**Town of Kittery
Planning Board Meeting
June 9, 2022**

28 Wyman Avenue —Sketch Plan Review, Cluster Residential Development

Action: Accept or deny plan as complete; continue application to a subsequent meeting; set site walk
Pursuant to Title 30-A M.R.S.A. §4401-4408 *Municipal Subdivision Law* and §16.8.10.H, *Cluster Residential Development* of the Town of Kittery Land Use and Development Code, owner Lusitano, LLC requests approval for a cluster residential development proposing three (3) single-family residences as a condominium on real property with an address of 28 Wyman Avenue (Tax Map 16, Lot 148) located in the Residential-Urban (R-U) Zone.

TITLE:
CONDOMINIUM SITE PLAN
 SHEET NUMBER:
C - 2

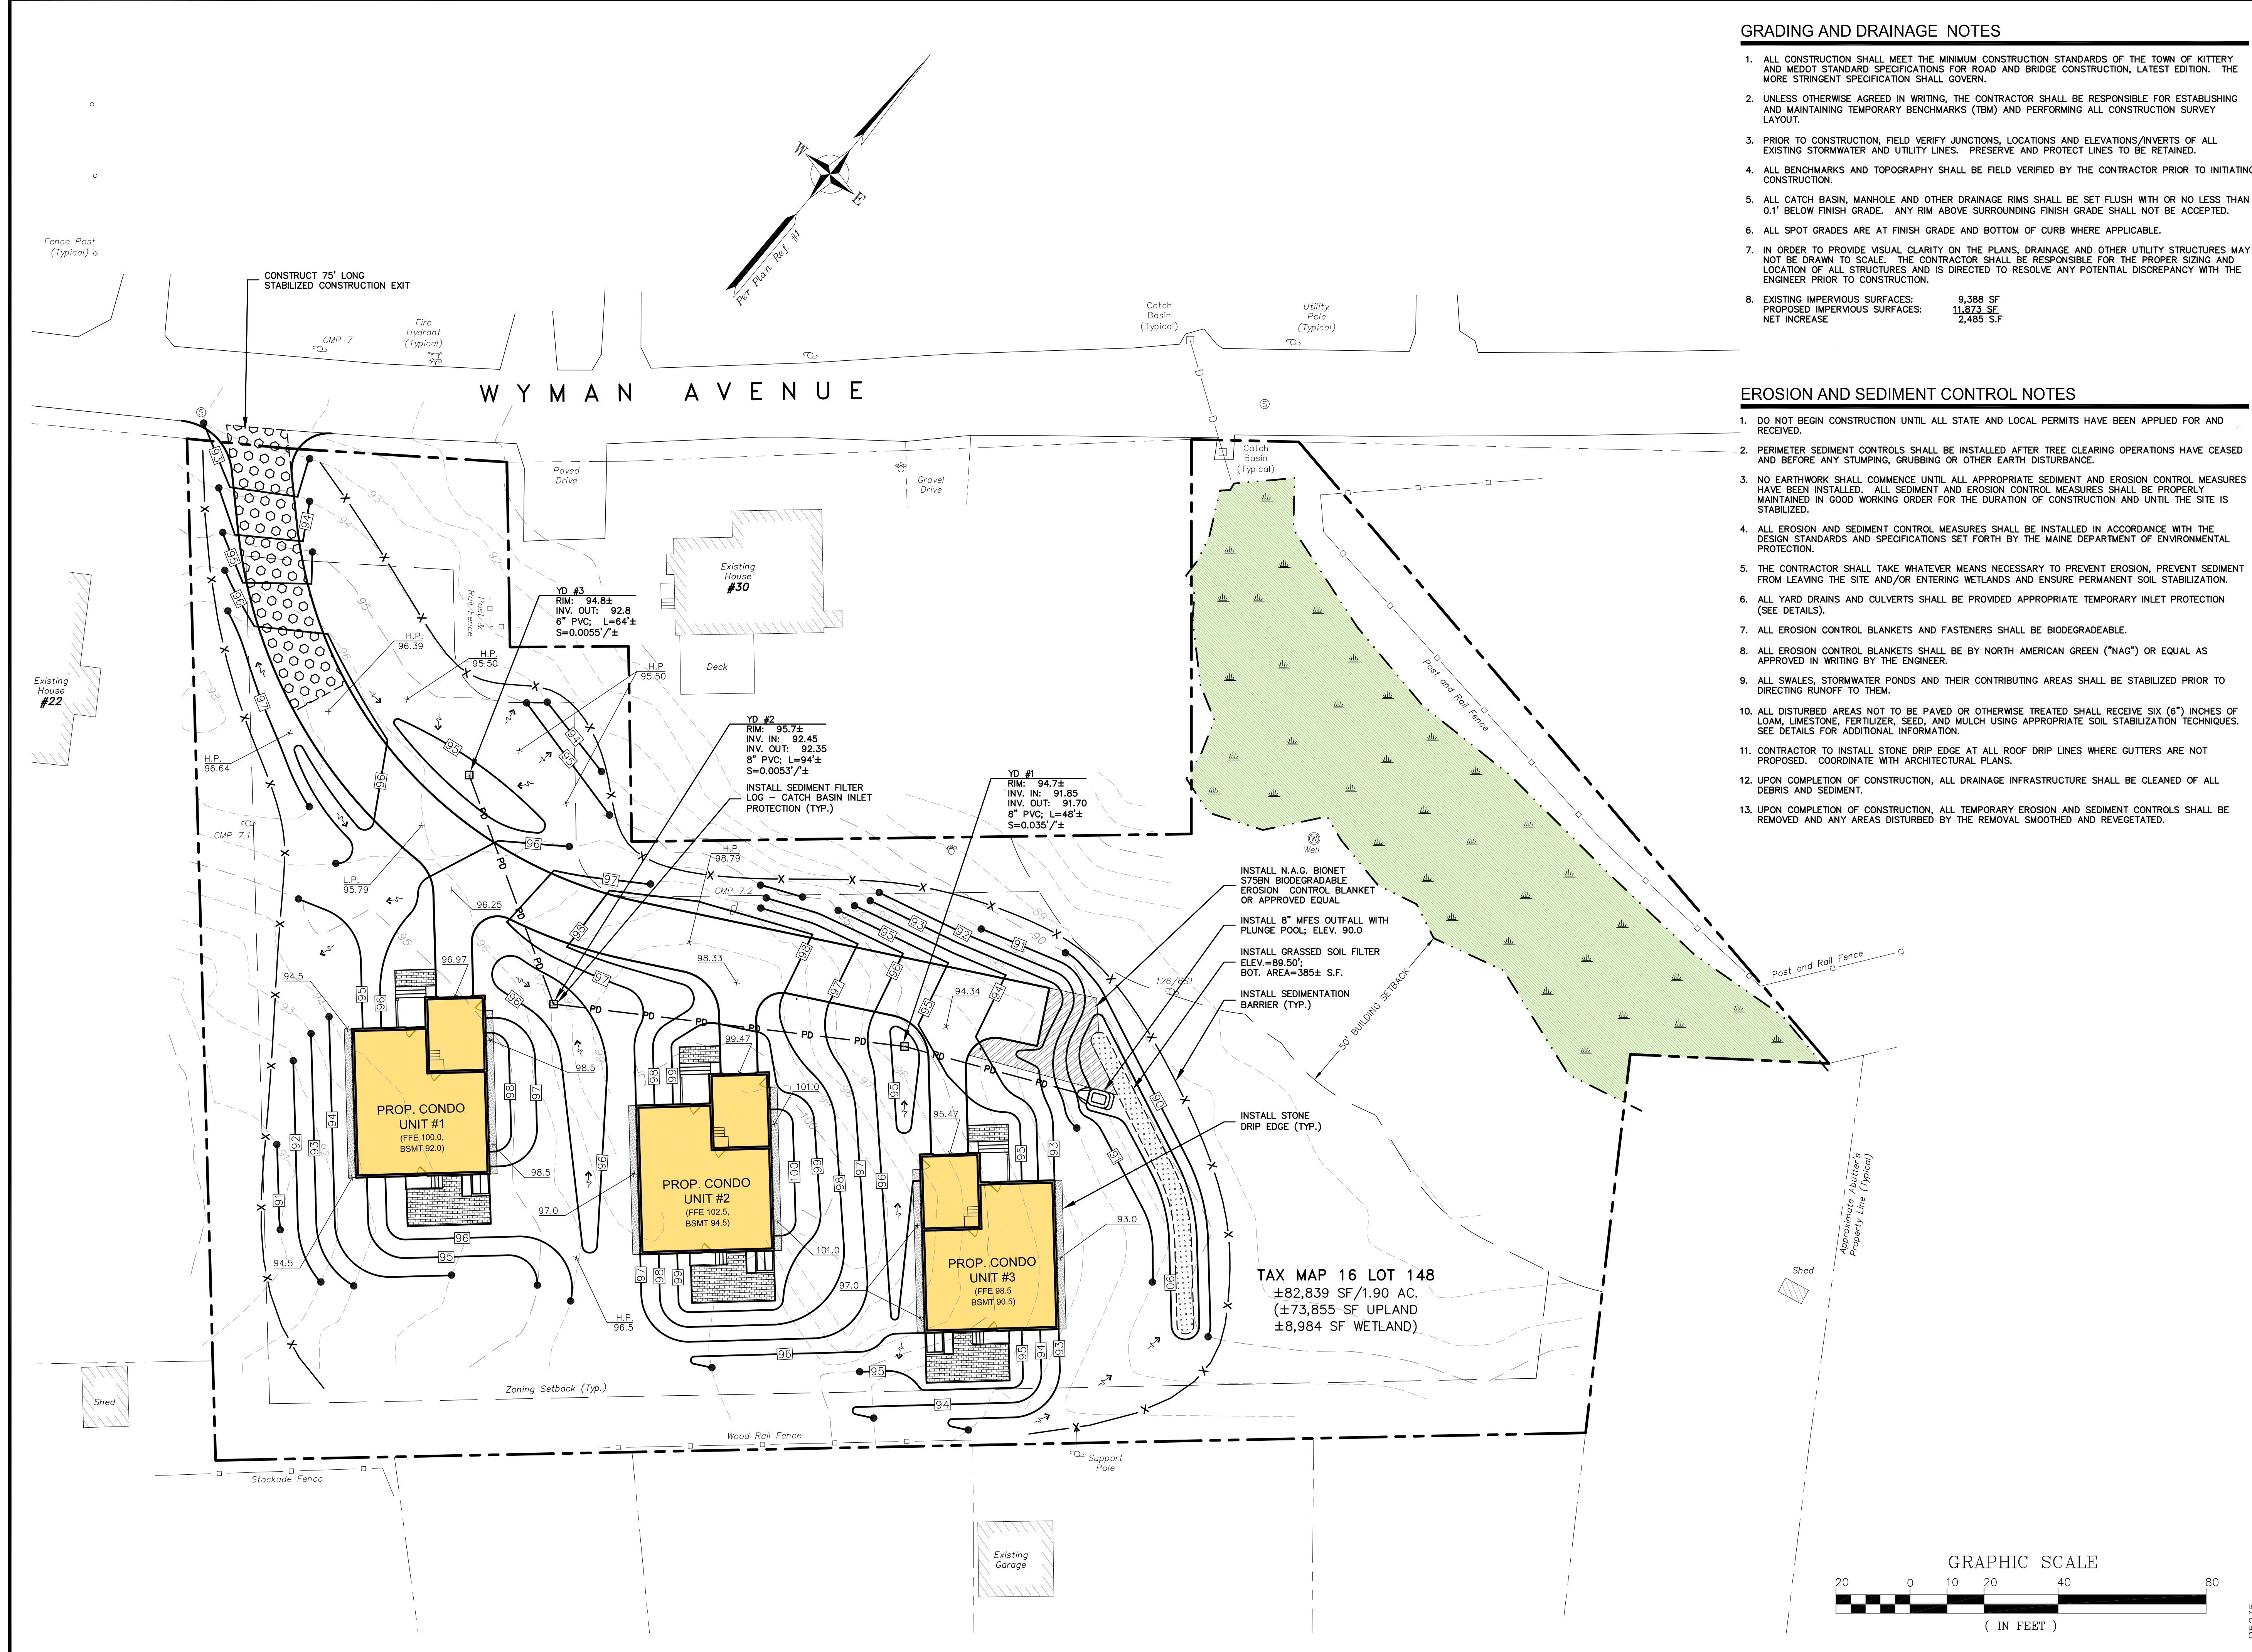
The plan highlights a “Common Area” green space on sheet C-2 but no additional information on what facilities or amenities might be included has been provided.

The plan highlights a “Common Area” green space on sheet C-2 but no additional information on what facilities or amenities might be included has been provided.

The Cluster Residential Development language in Section 16.8.10.H. requires that open space must contain at least 50% of the total property area and 30% of the net residential acreage. This plan appears to meet those thresholds; however, the applicant should provide this information more clearly in the site notes.

The proposed residential structure closest to the wetland is shown to be over 100 feet from the wetland. The end of the shared driveway (per §16.3, a driveway may service two or less residential units) depicted on the plan is located approximately 65 feet from the wetland. Per Table 16.5.30 *Minimum Setbacks from Wetlands and Waterbodies*, a traveled way of road or driveway can be located 10 feet from the wetland. Rear and side setbacks for the R-U zone are 15 feet which is the requirement (see §16.4.13.D)

The plans show a 16-foot-wide private way which extends just past Unit 1. From there, a common driveway provides access to Unit 2 and 3. Because the street frontage for this property is nonconforming (less than 100 feet) and the proposed use is intensifying from one residential use/building to three residential uses/buildings, the private road will serve to provide both access and frontage to the units. However, it is not required for each unit to have its own 100-foot frontage though because it is a condominium – one lot shared in common by three residential units. As shown on the plans the private way is over 100 feet long, thus providing the frontage required for the condominium. The private way will be named by the applicant (once the name is approved by the Town's addressing officer) and all three units will derive their addresses from that road, if the plan is approved.

While the plan does show a small amount of common pavement between Unit 1's limited common area driveway and the road and again at the very end of the proposed pavement beyond Unit 3, neither is sufficient for a turnaround without travel into the private driveways. Because adequate emergency vehicle access must be assured, in addition to other vehicles who may need to turn around, the Fire Chief will be asked to weigh in at the sketch plan phase because a minor subdivision moves from sketch to final plan without a preliminary phase.

Per §16.8.10.H.(6).(e), a cluster residential development must provide open space. The requirement is that 50% of the lot must remain undeveloped (which usually includes all the wetlands, water bodies etc.) with 30% of that comprised of upland. No open space calculations are shown. A label on the plan reads “Common Area (plus/minus 69,352 ft/1.59 acres)”. Staff noted to the applicant’s engineer that the limited common areas around each residential unit are very limited and suggested that more area around each unit for private enjoyment would be well-received. This would presumably cut into the 1.59 acres of common space that also serves as open space.

Recommendation: Staff recommends that the open space calculations be added to the plan notes and that the open space be shown clearly and labeled as such on the plans.

TITLE:
UTILITY PLAN
 SHEET NUMBER:
C - 4

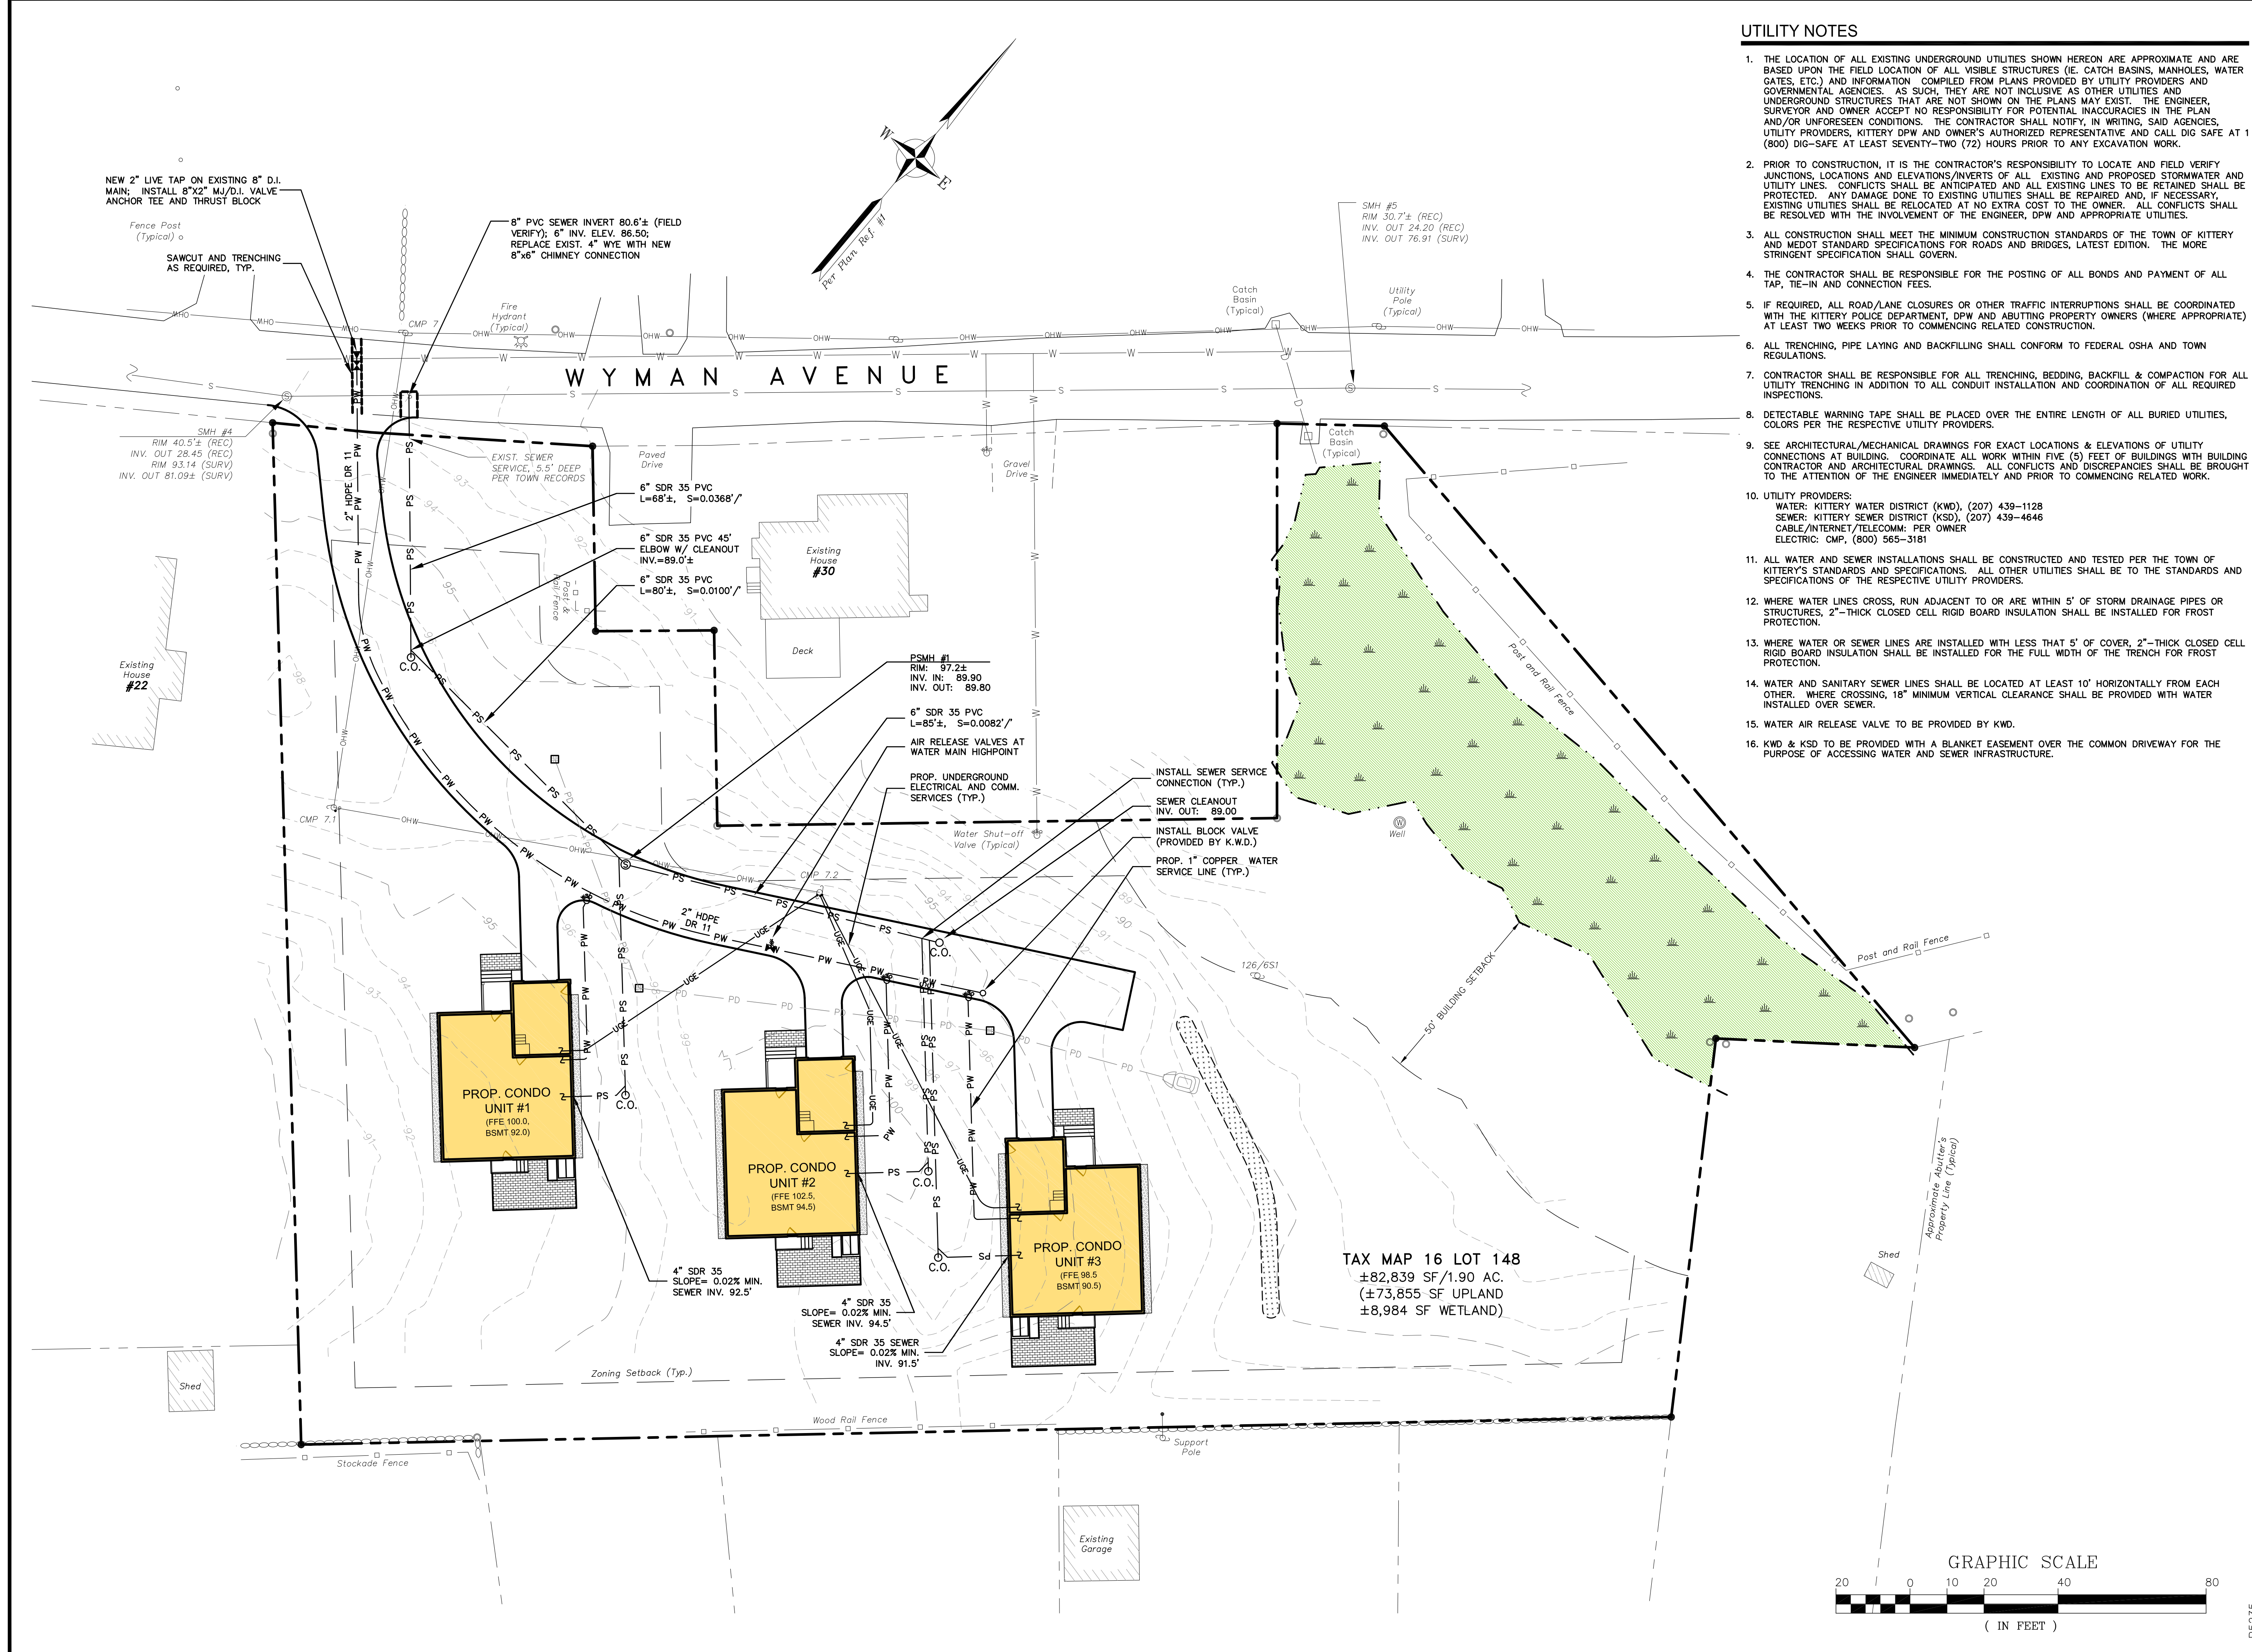
The site plan (sheet C-4) shows the plan for utility services. The plan shows using an existing sewer connection, as well as using an existing water connection. Existing overhead electrical lines will terminate at a new pole where underground electrical service will extend to each condo unit. A stormwater management plan has been supplied with drop inlets connected to an outfall at the eastern edge of the property. This outfall appears to be located in an area labeled “Common Area” on other plan sheets.
